**LAKE MANITOBA AND LAKE ST. MARTIN OUTLET CHANNELS PROJECT
RESPONSE TO IAAC TECHNICAL INFORMATION REQUESTS**

Question IAAC-28a

QUESTION IAAC-28A

DRAFT IR Map 28-1

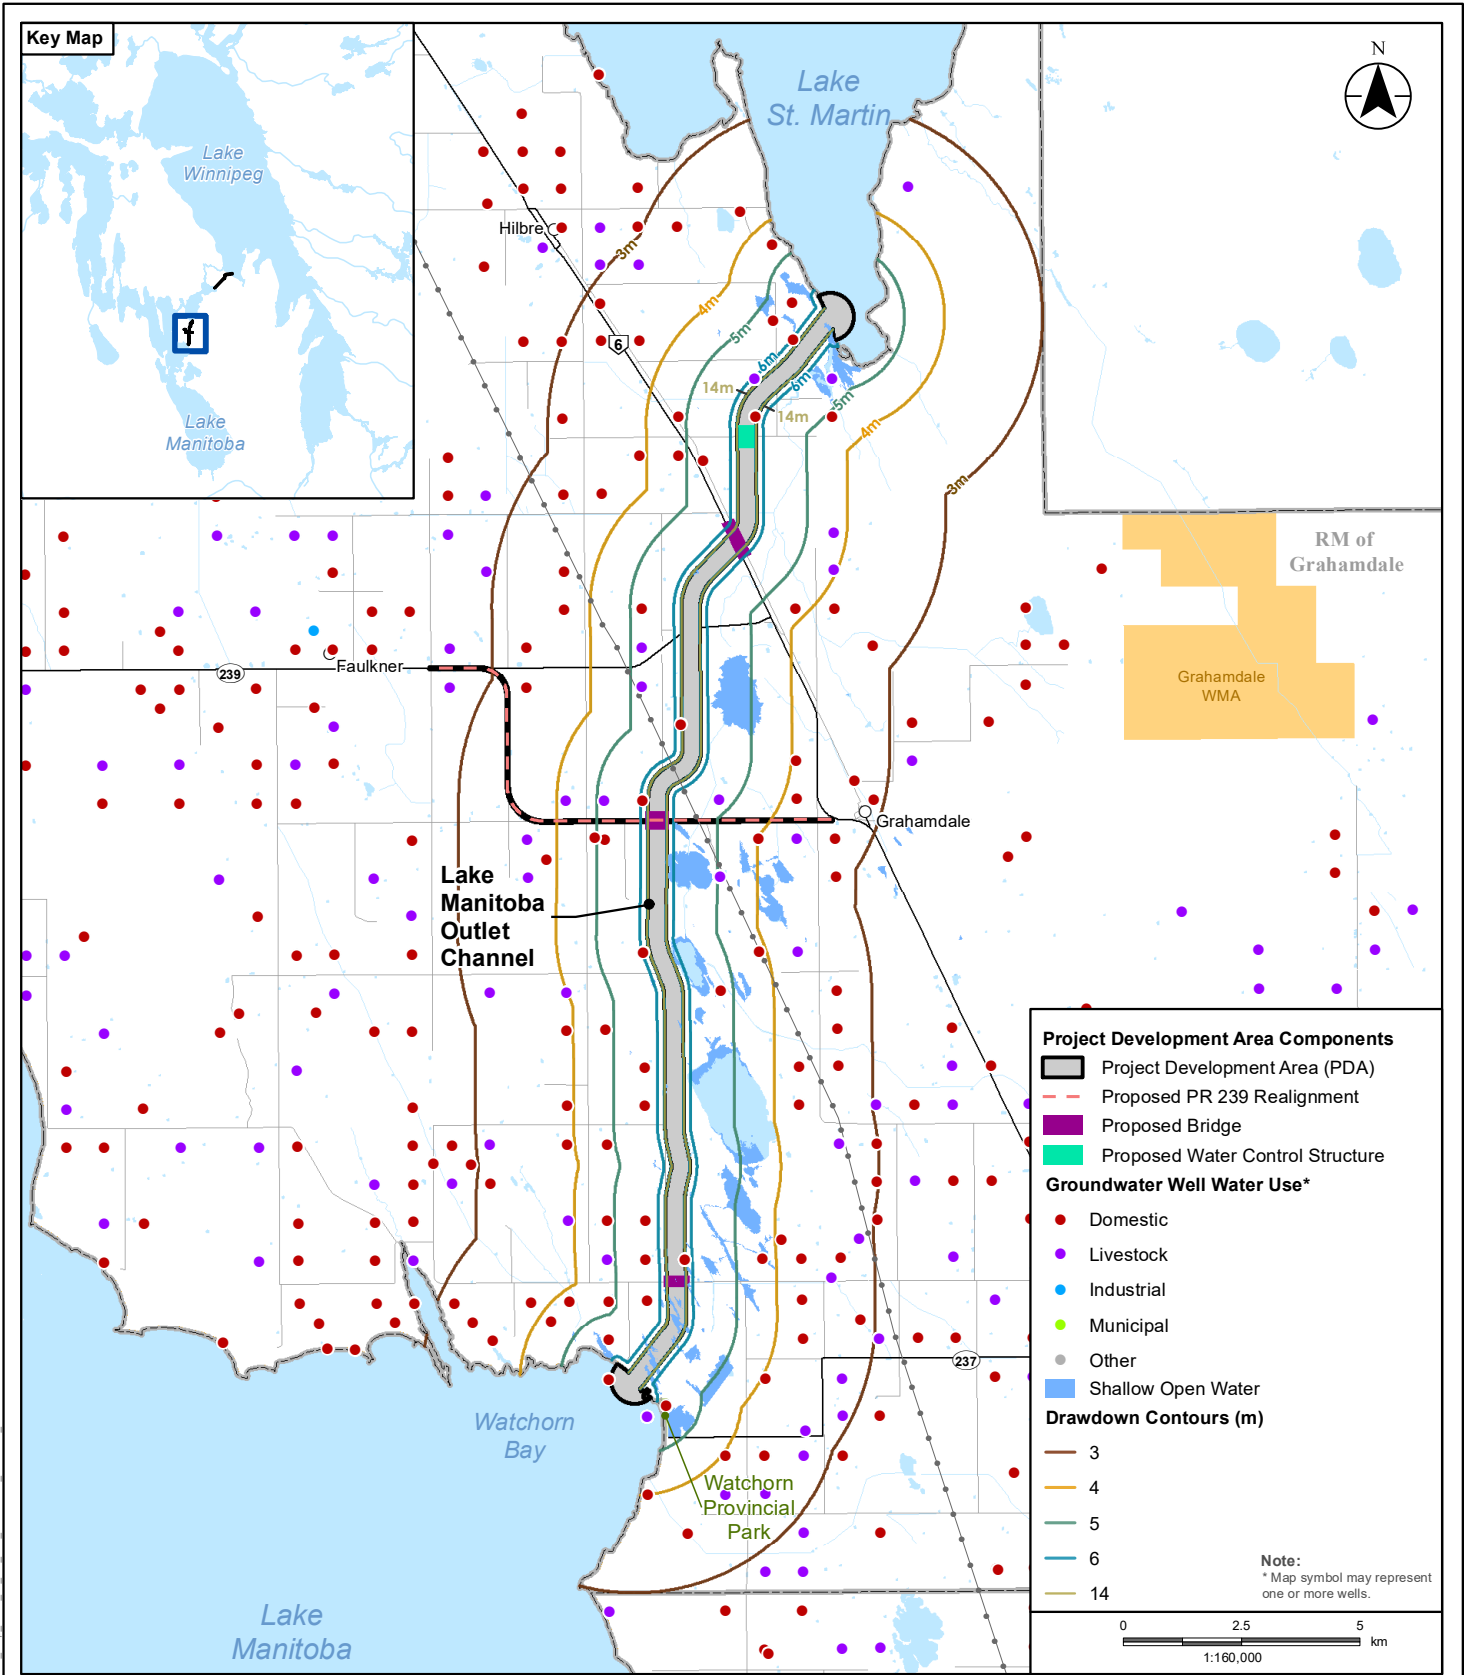
Additionally, as shown on Figure 6.4B-5, many domestic wells are within the three km buffer surrounding the LMOC. These wells may experience more than three m of drawdown based on the results provided on Plate D6-5, of Deliverable 6 (KGS, 2017a).

- a) Discuss the likely available drawdown for domestic wells within the LAA for the LMOC. Provide updated figures that show the predicted drawdown contours based on the modeling.

The available drawdown at domestic wells are not available at this time and will be determined in the Engineering phase and discussed with landowners (see (e) below). The expected drawdown contours of effects of the Project on groundwater during construction are shown on Map 28-1. Note that construction will take place in stages along the channel and each stage will create a single drawdown contour so the effects are not occurring simultaneously away from the entire channel. Areas of active construction along the LMOC will have a 3-5 km drawdown around it. The contours shown are the overlapping effects of each of the construction dewatering stages. The details of construction staging are not currently known.

If there is no passive depressurization along some reaches of the channel, then the drawdown contours in the bedrock will be less than shown in Map 28-1; however, there will be a drawdown in the surficial aquifer near the channel. Effects on surficial geology (soils and till) will occur due to improved drainage around the LMOC. Effects are expected to remain within the right-of-way (ROW) of the channels.
